**ADDENDUM NO. 2**

**TOWN OF INDIAN HEAD, MARYLAND**

**TRAILHEAD RESTROOM  
SHA No. CH257B51  
FAP No. AC-TAP-3(871)E**

TITLE		PICNIC SHELTER/RESTROOM ARCHITECTURAL FLOOR PLAN & ELEVATIONS	
SCALE	0 2 4 8 12	DWG. NO.	A-1
PROJECT NO.		SCALE: 1/4" = 1'-0"	
10611	7 OF 13	REV.

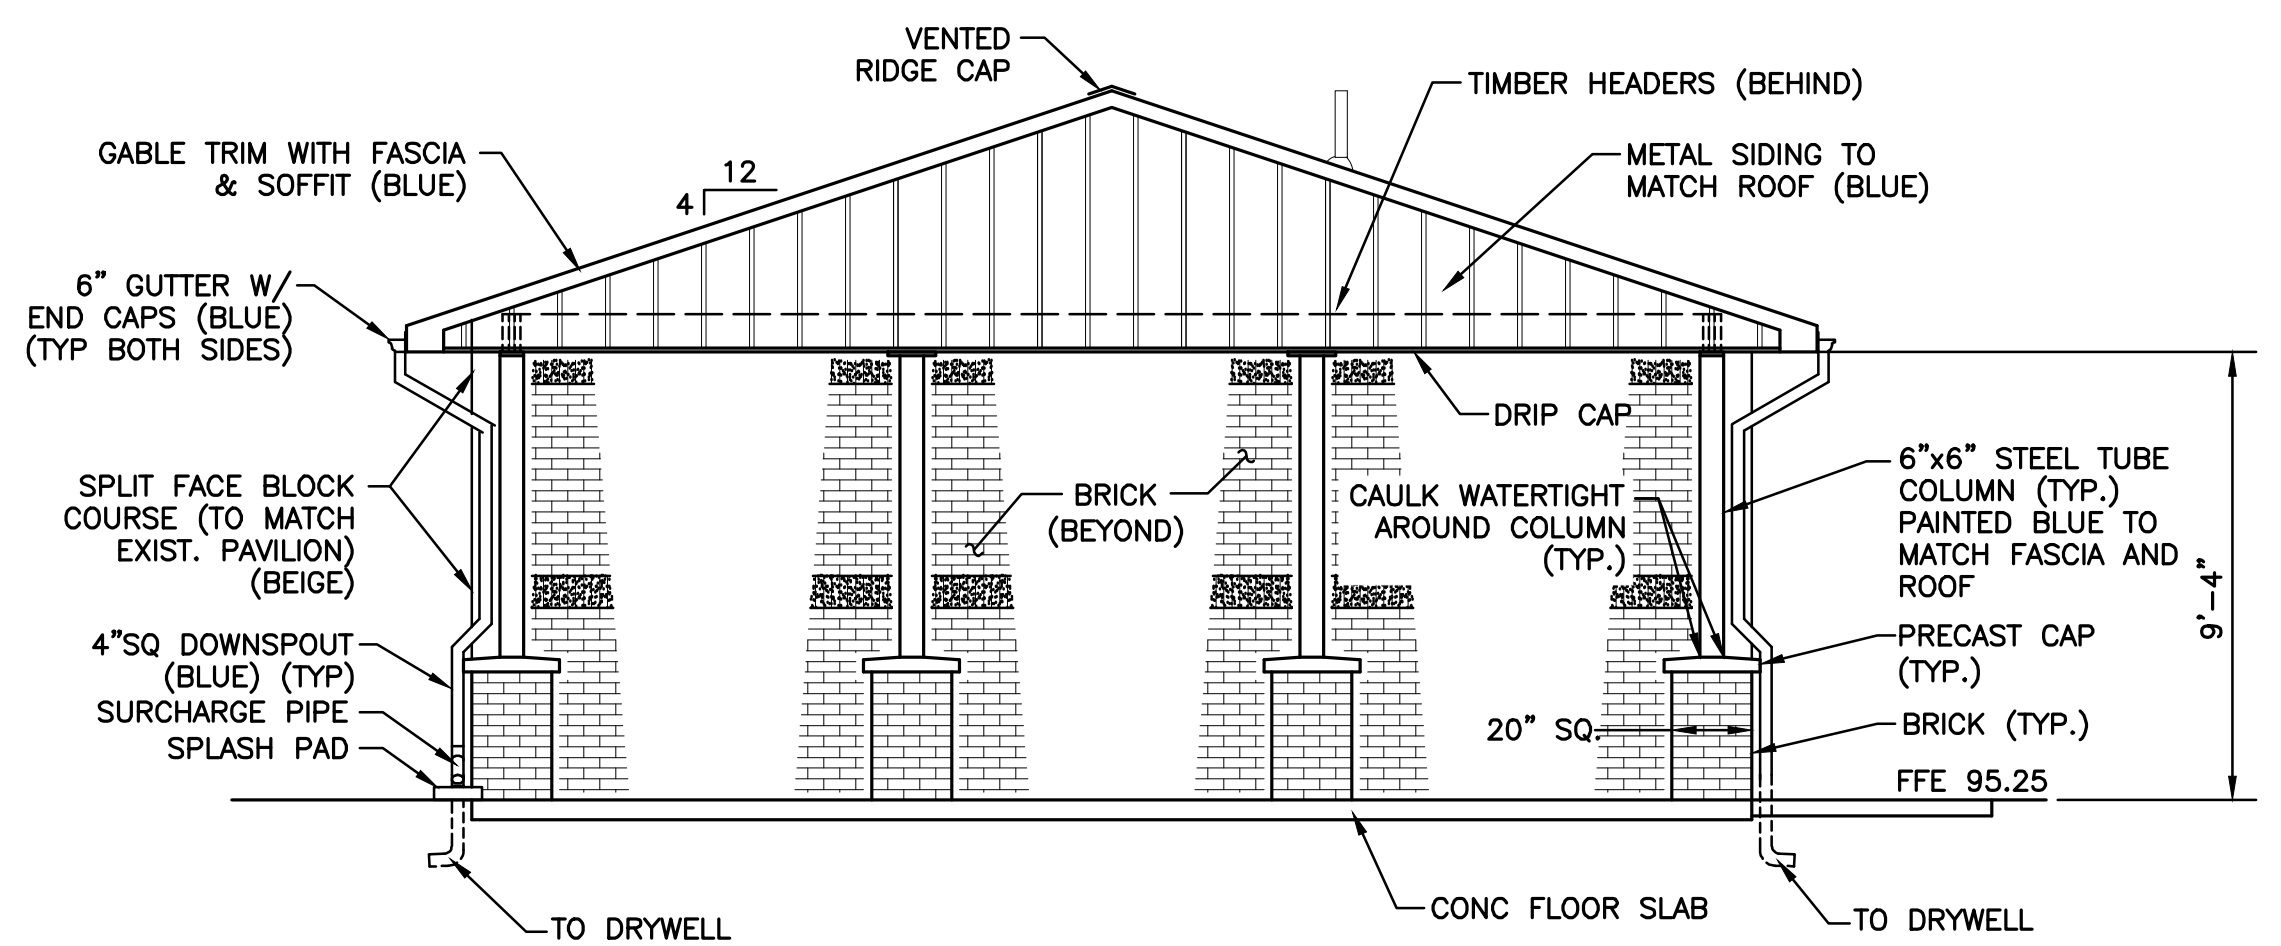
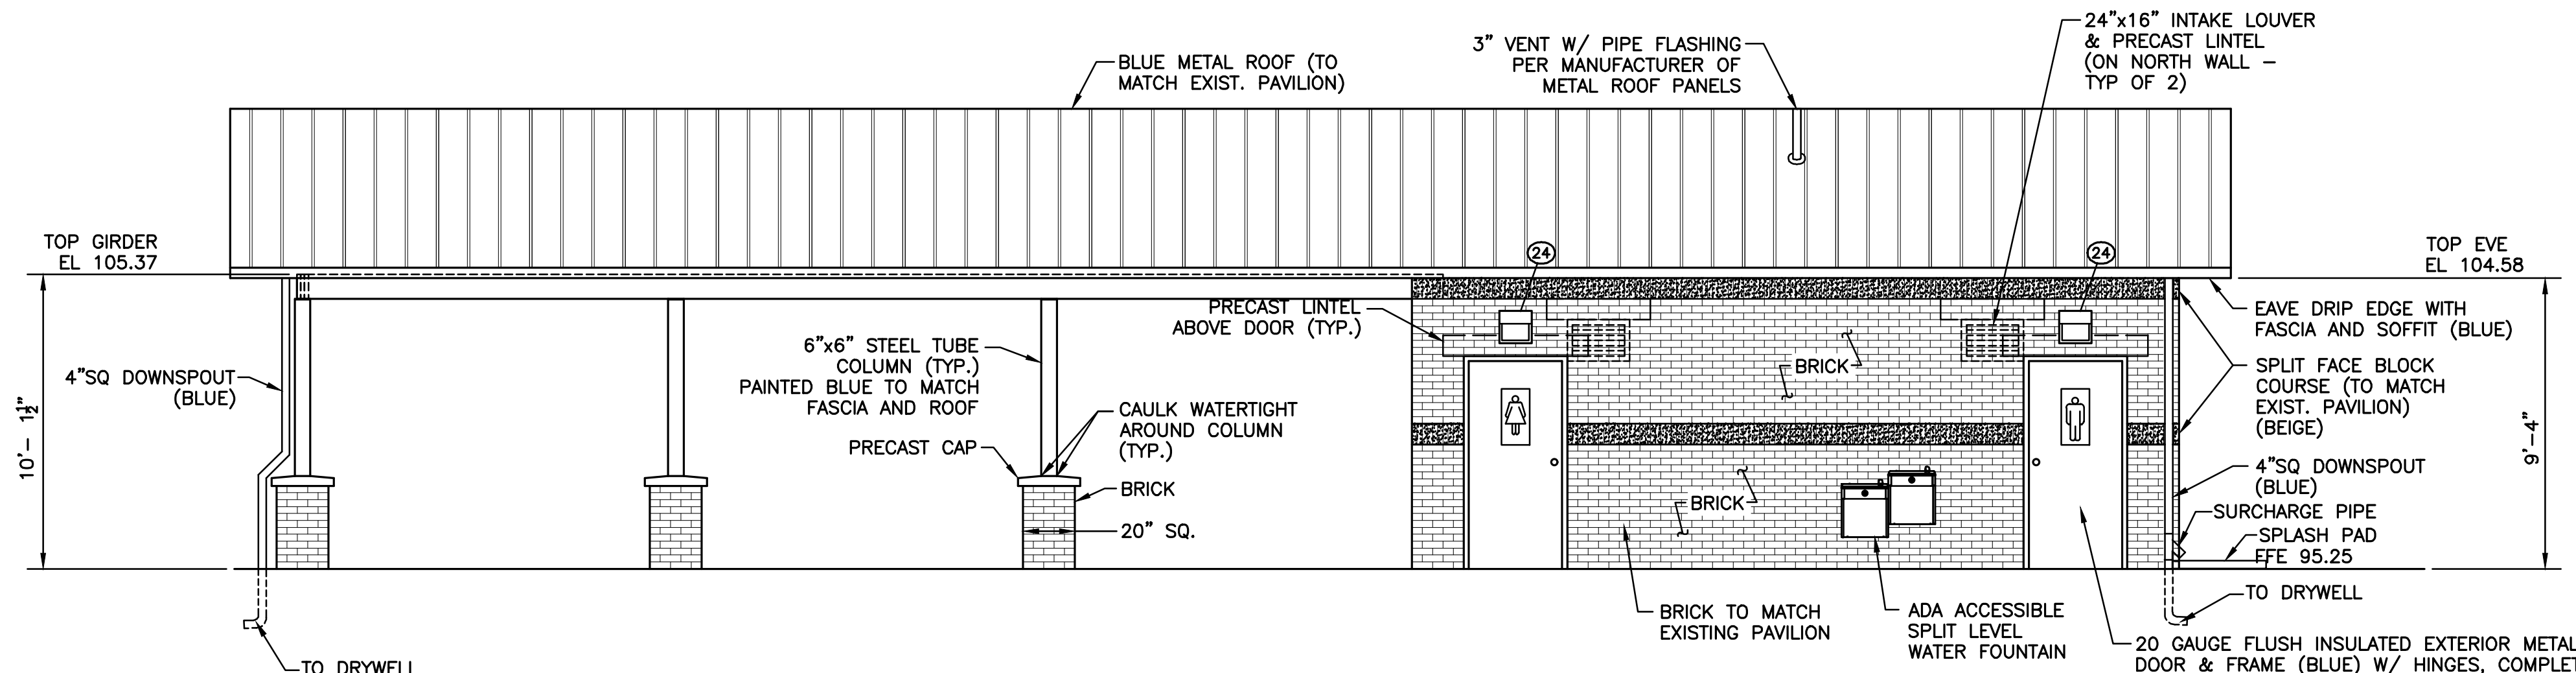
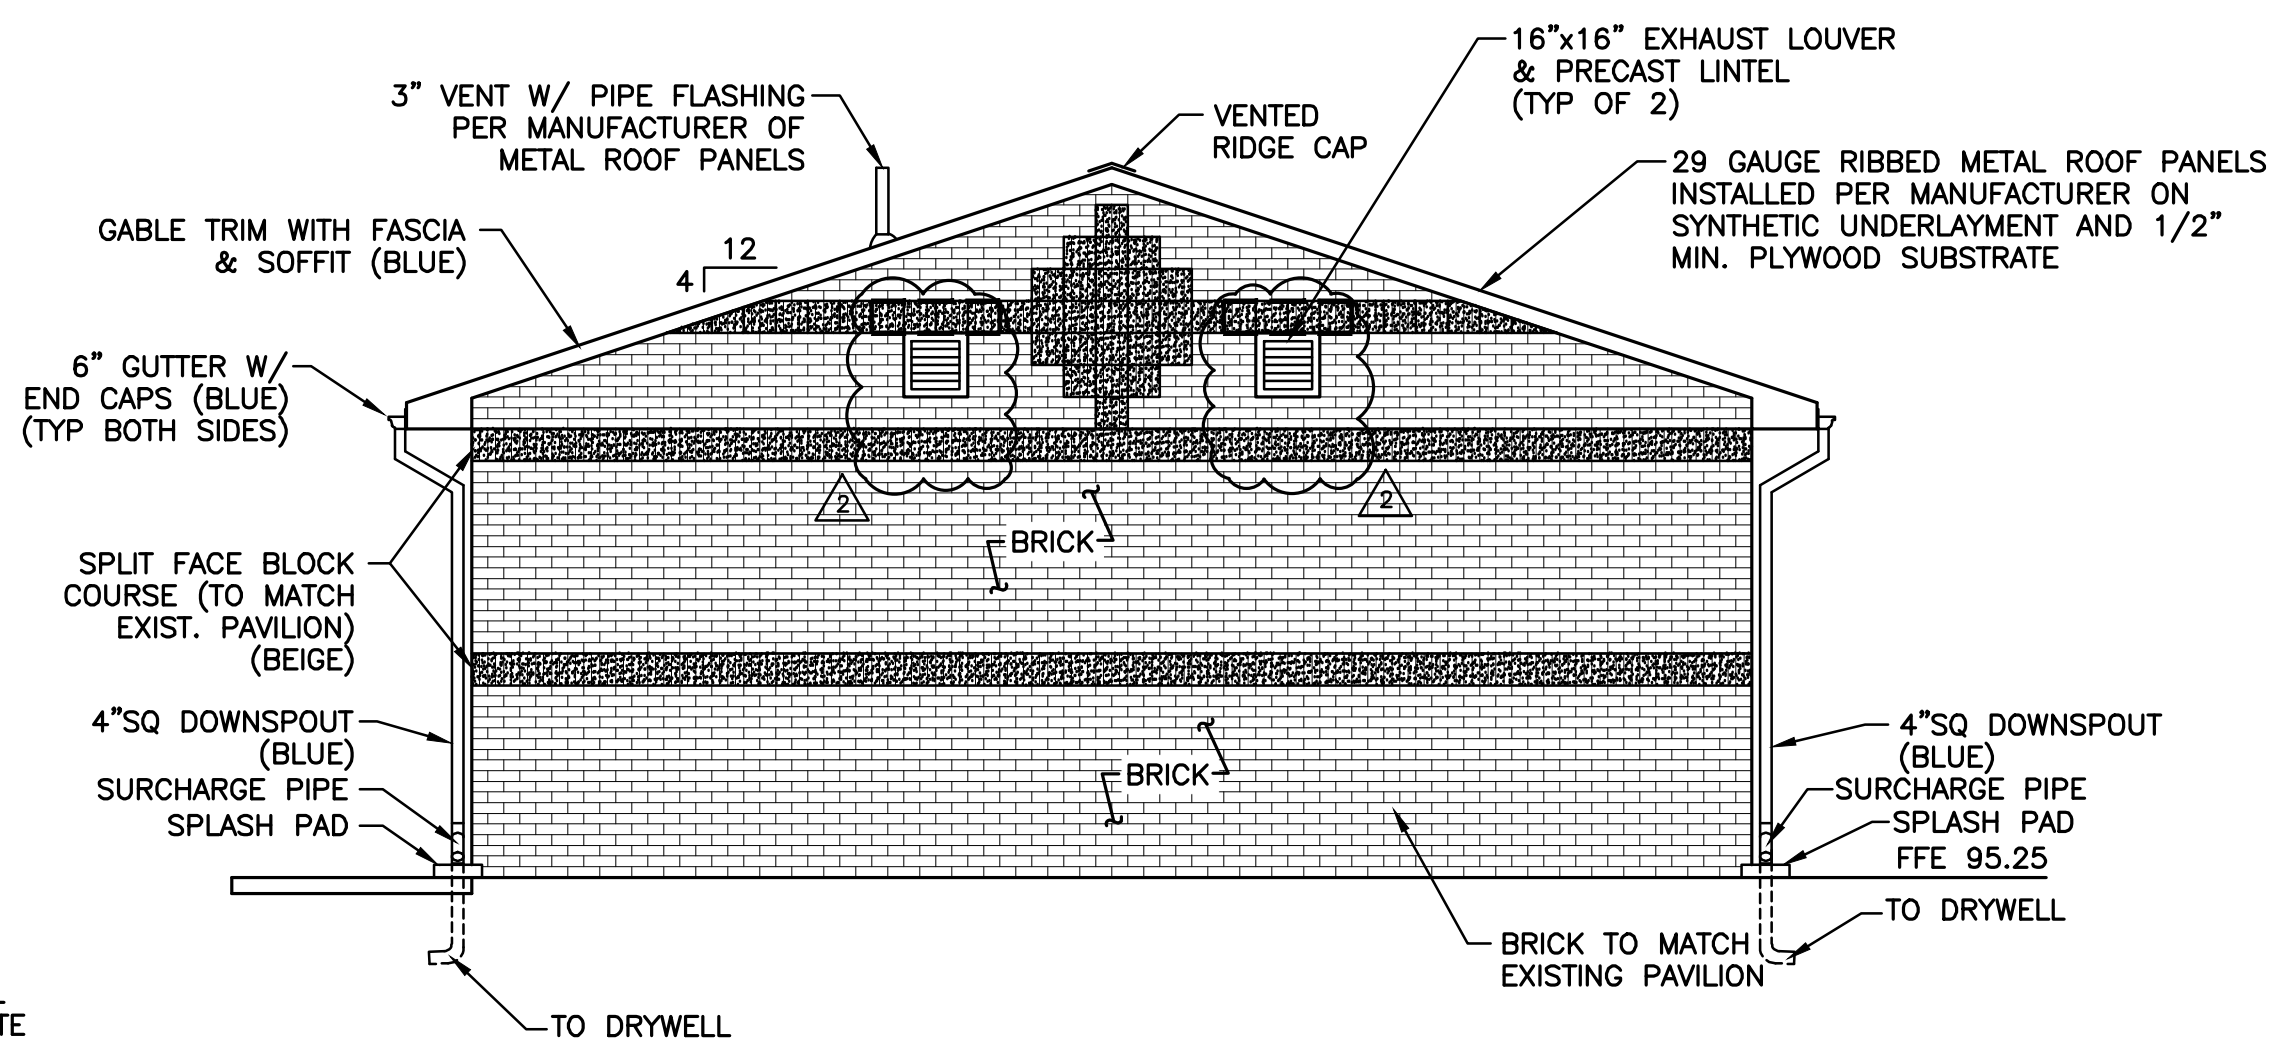
Question 5. The elevation of the louvers is unclear. If we course the block it appears the intake louvers is both above and below the ACT and the exhaust are shown at an elevation above the bottom of the trusses.

**Response: The bottom of exhaust louvers shall be placed at 10’-0”. Please see ‘Concerning the Drawings’ for an updated plan and detail.**
